ART Libby
Job: Swift
Cliff Island

Revision 1, 7/8/17, WLS
Added note to identify anchor detail.

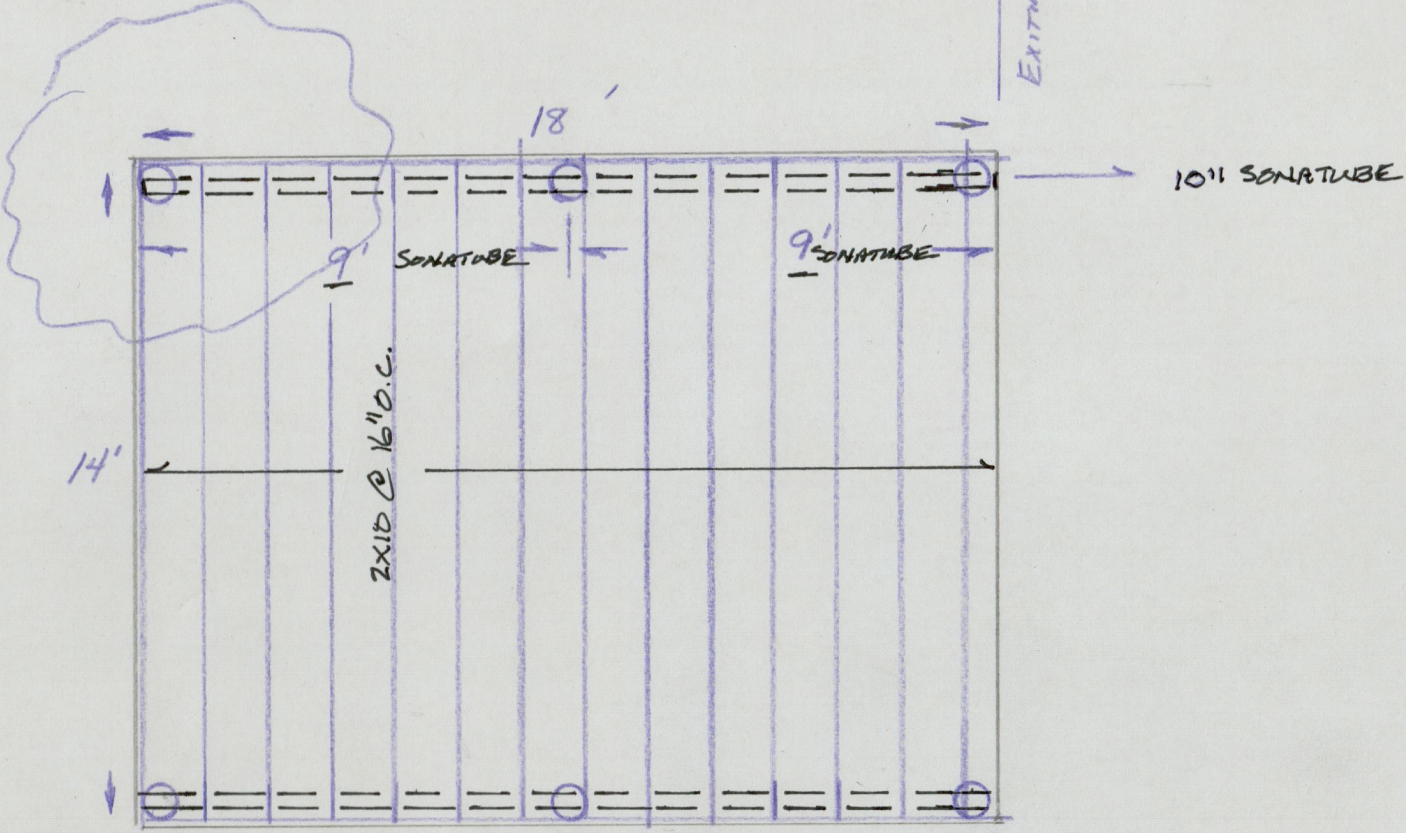
See drawing Swift Addition Anchoring Detail for detail
